# ADDENDUM

ADDENDUM NO: 4

PROJECT: Hamilton Heights High School Phase 2 Projects

PROJECT NO: 2023060

**DRAWING NUMBER:**  
**E100**

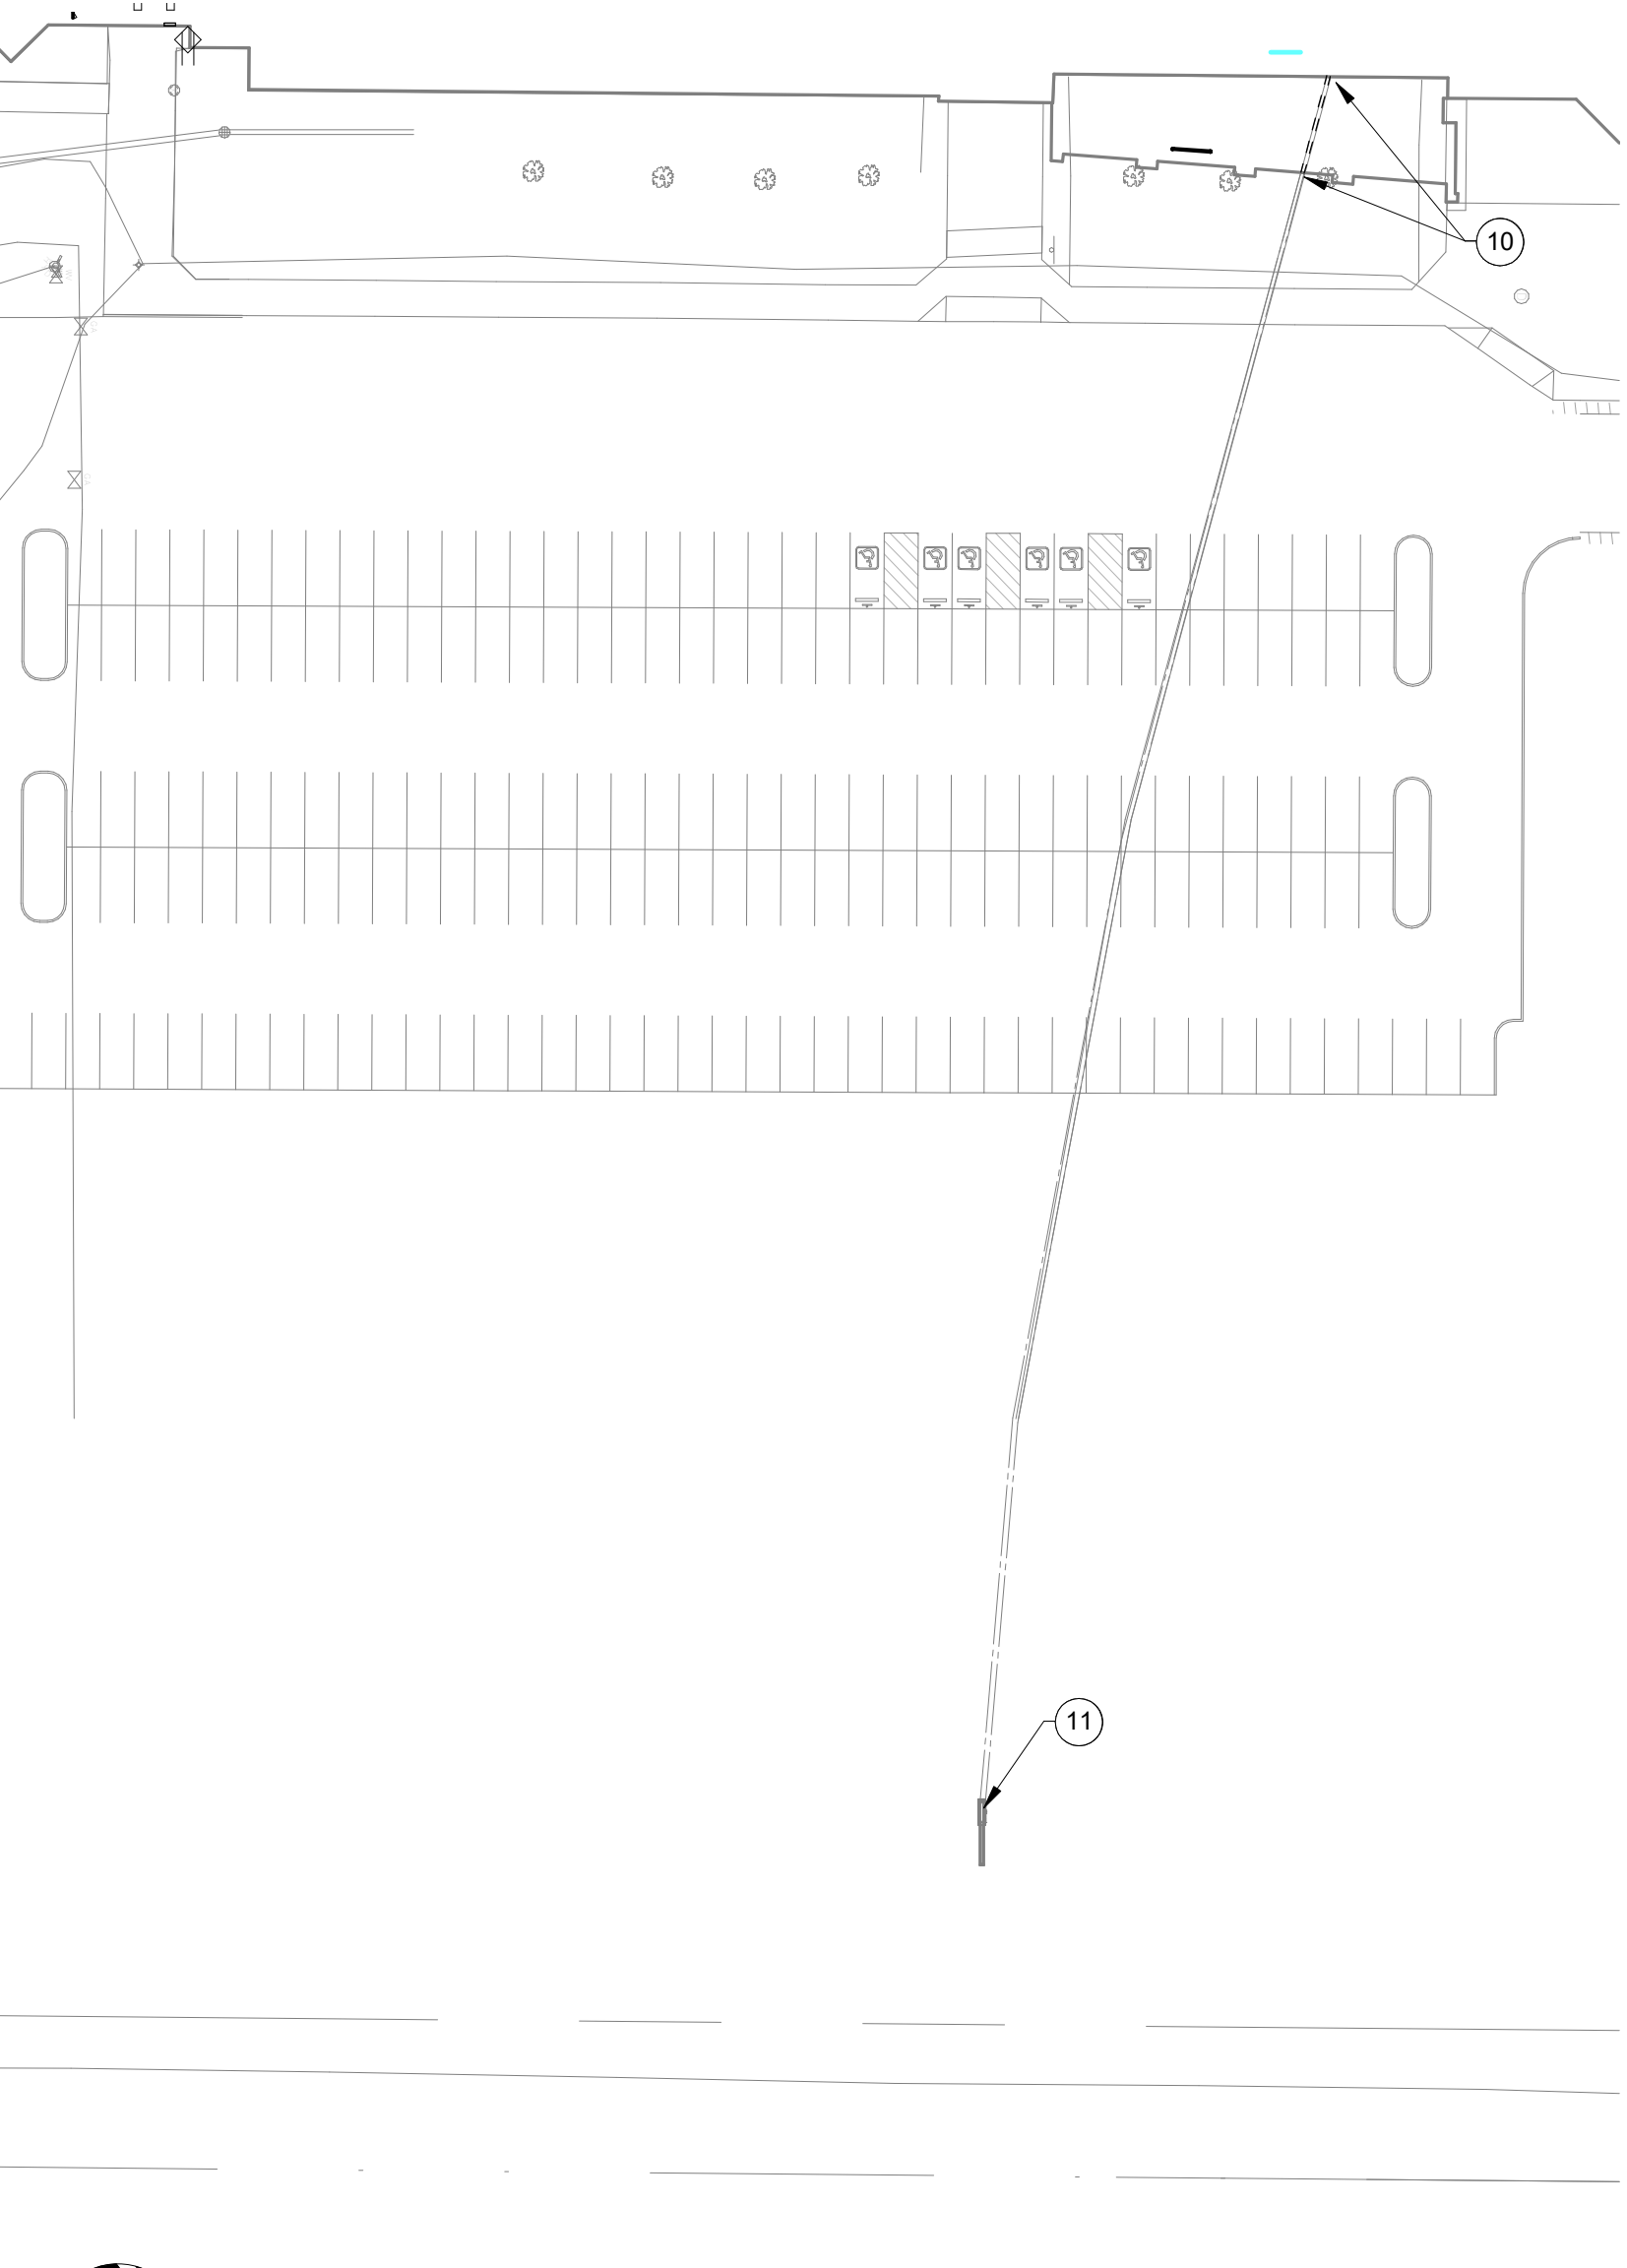
- A. Add Plan Notes for refeeding existing loads
- B. Reissue drawing in its entirety

19. EXISTING PARKING LOT LIGHTING TO REMAIN. EXTEND NEW CIRCUIT FROM NEW LIGHTING TO THIS FIXTURE.
  20. SEE POLE BASE DETAIL ON DRAWING E403.
  21. PROVIDE NEW CIRCUITS FROM PANELBOARD 'OL4' TO EXISTING ELECTRIC HANDHOLE FOR EXISTING TENNIS COURT AND STORAGE BUILDING CIRCUITS FED FROM DEMOLISHED LOCKER BUILDING. (7) 120V, 20A/1P CIRCUITS MATCH EXISTING CONDUCTOR SIZES.

22. INTERCEPT EXISTING CIRCUITS FOR EXISTING DUGOUTS FED FROM DEMOLISHED LOCKER BUILDING TO CIRCUIT INDICATED. FIELD VERIFY LOCATION OF UNDERGROUND CIRCUITS AND PROVIDE HANDHOLE COORDINATE LOCATION OF HANDHOLE WITH OWNER/ENGINEER PRIOR TO ROUGH-IN. MATCH EXISTING CONDUCTOR SIZES.

23. INTERCEPT EXISTING CIRCUITS FOR EXISTING SCOREBOARD FED FROM DEMOLISHED LOCKER BUILDING TO CIRCUIT INDICATED. FIELD VERIFY LOCATION OF UNDERGROUND CIRCUITS AND PROVIDE HANDHOLE COORDINATE LOCATION OF HANDHOLE WITH OWNER/ENGINEER PRIOR TO ROUGH-IN. MATCH EXISTING CONDUCTOR SIZES.

DRAWING NUMBER  
E213

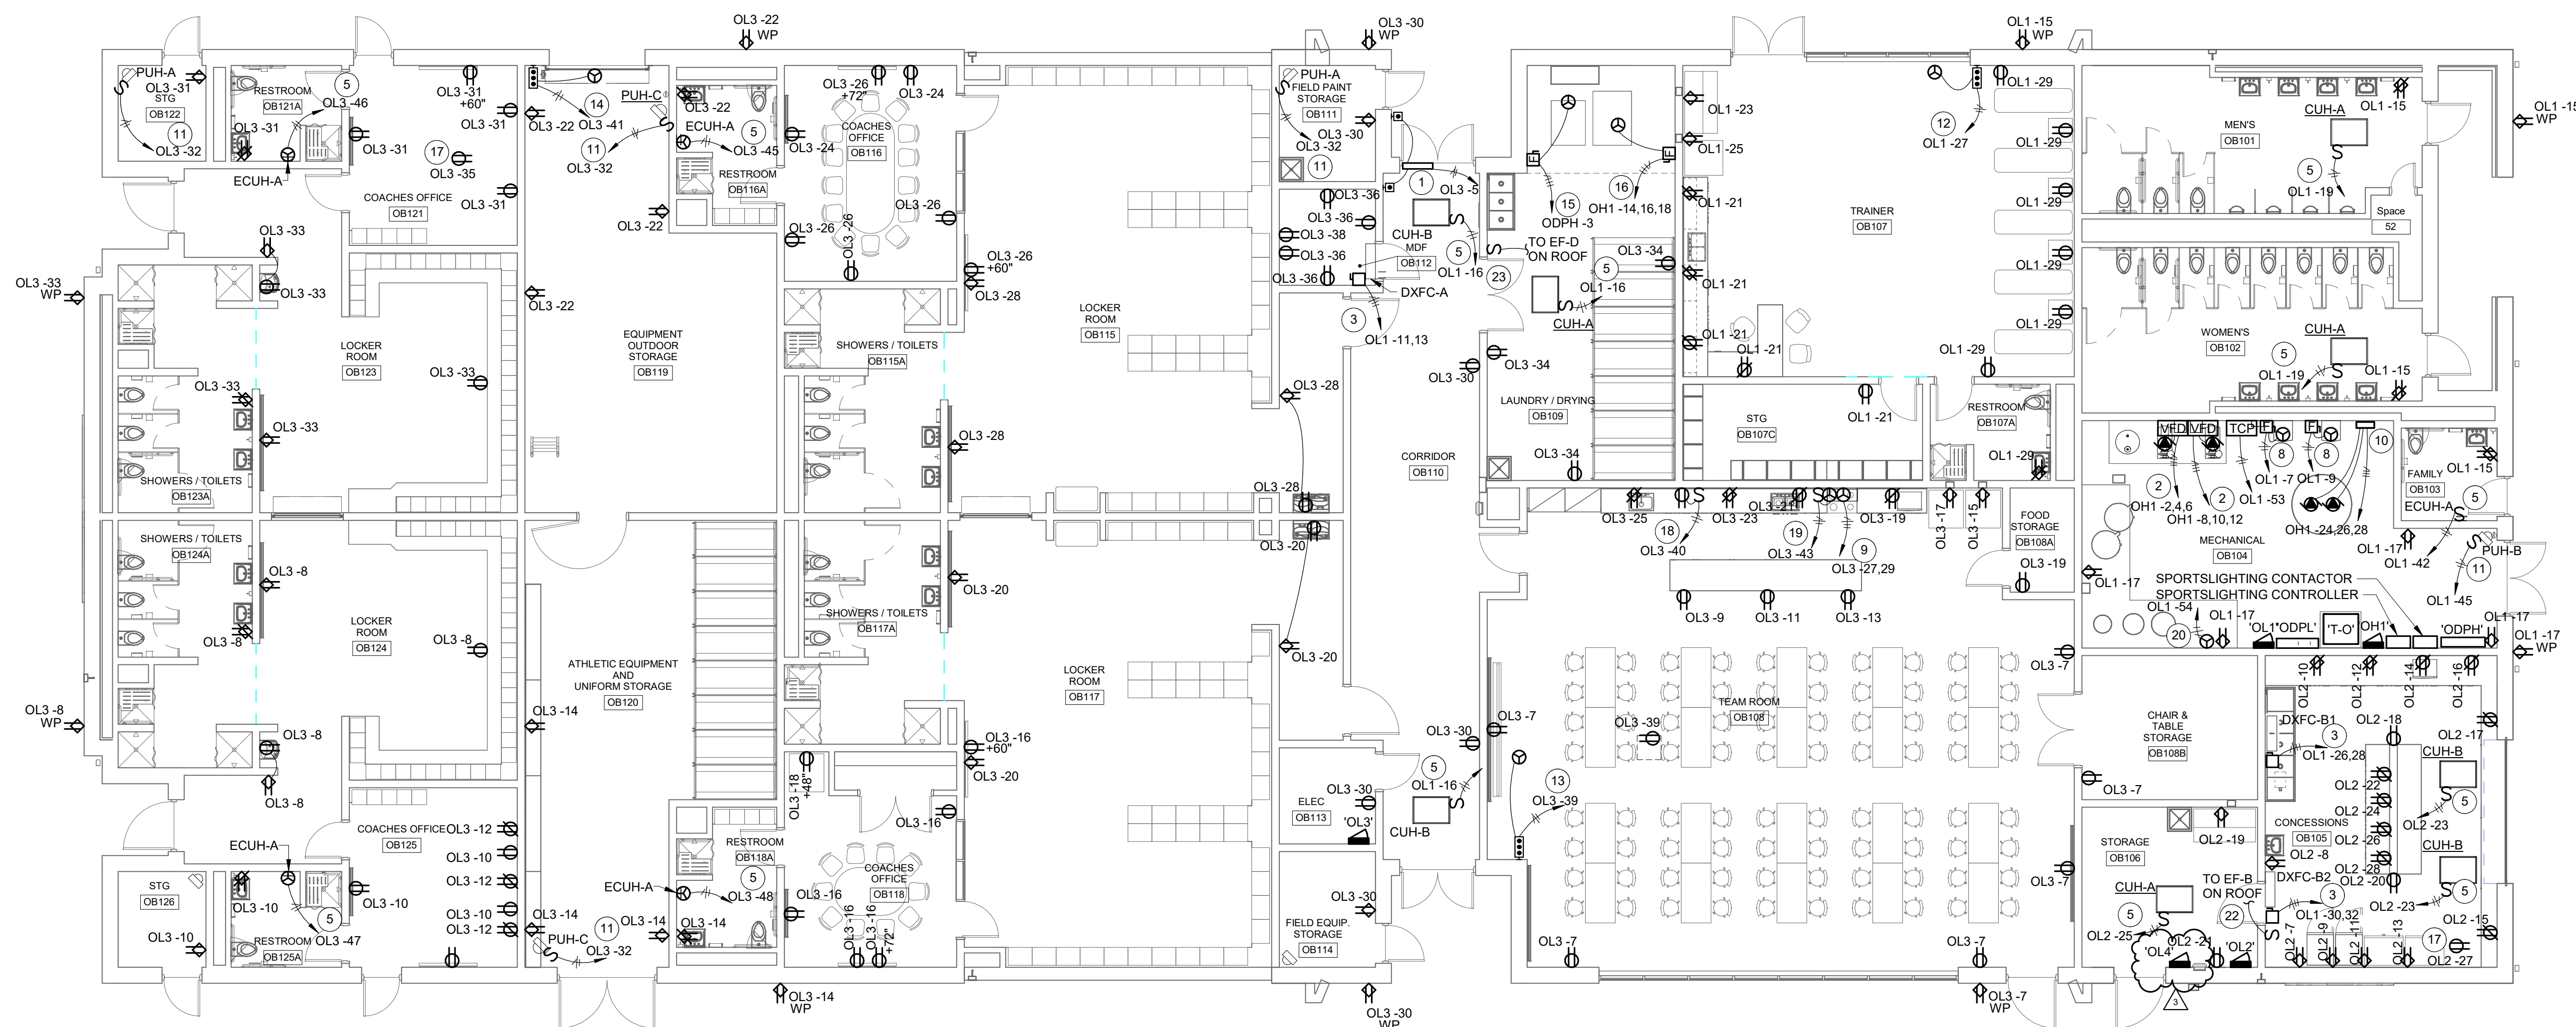
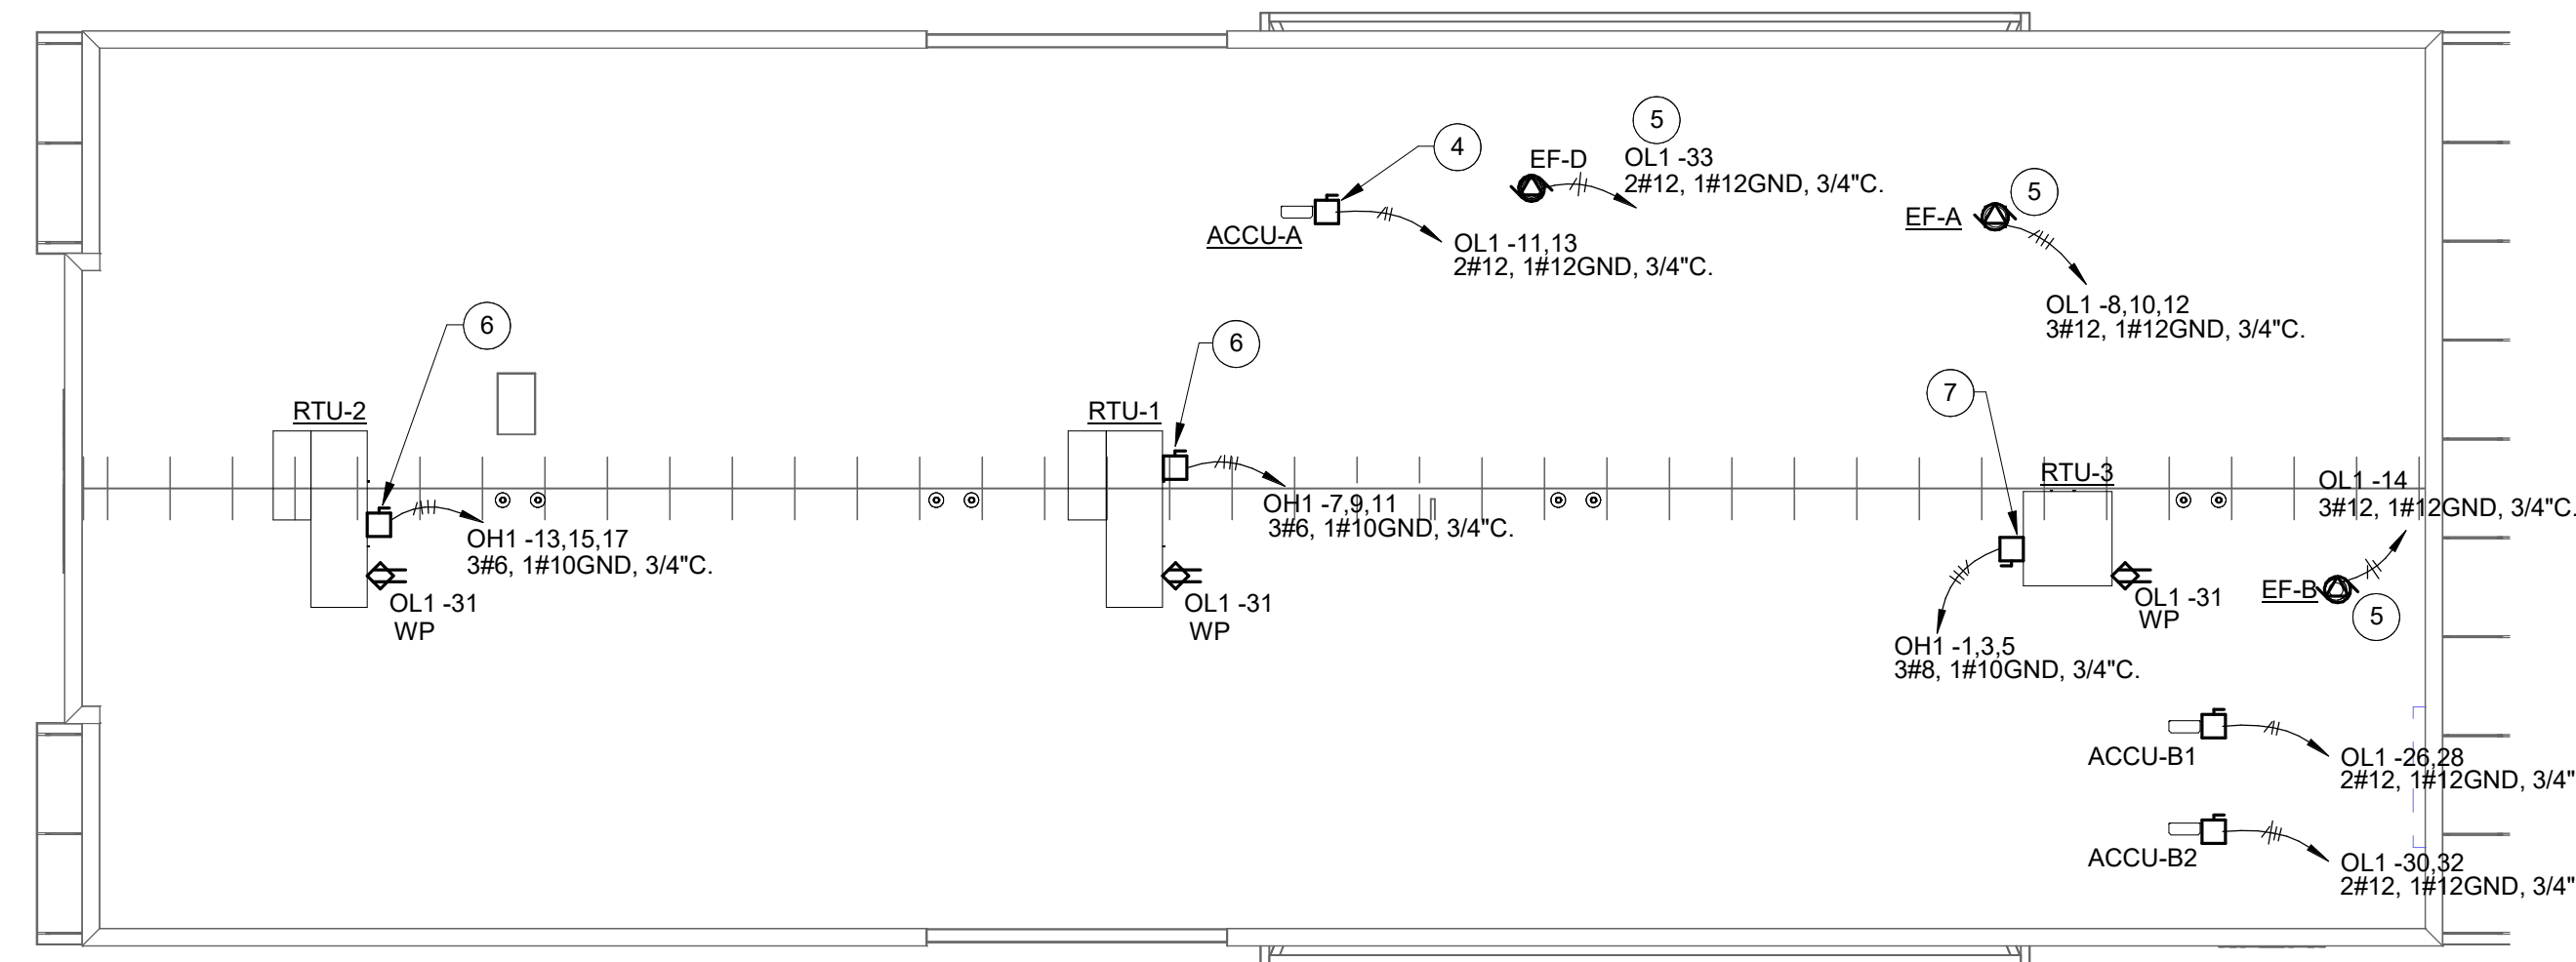
- A. Add Panelboard OL4.
- B. Reissue drawing in its entirety.
